Dam ID: HI 00065
UPPER ANAHOLA

STATE OF HAWAII - DLNR
DAM SAFETY INSPECTION SHEET

Inspection No: _____
Date: 4/9/06

Additional Comments:

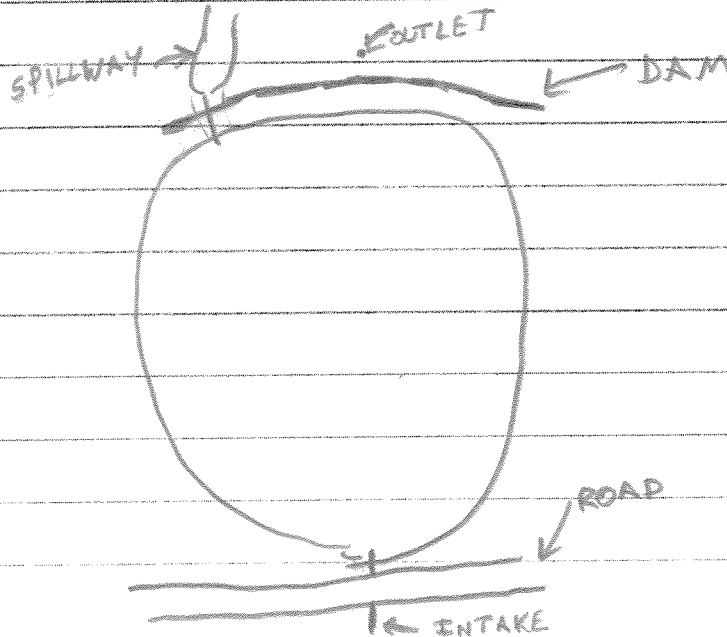
- INSPECTORS WERE TOLD RESERVOIR IS ABANDONED
- PROPER ABANDONMENT HAS NOT OCCURRED. DAM SHOULD BE BREACHED ^{TO BOTTOM OF RESERVOIR} TO ALLOW FOR PROPER ABANDONMENT.
- INTAKE PIPE SHOULD BE CLEANED TO PREVENT FLOWS FROM CONTINUING TO FLOW OVER ROAD. PIPE MAY NEED TO BE REPLACED W/LARGER PIPE TO ALLOW FOR PASSING OF DESIGN FLOWS.
- NO OUTLET WORKS CONTROLS WERE FOUND
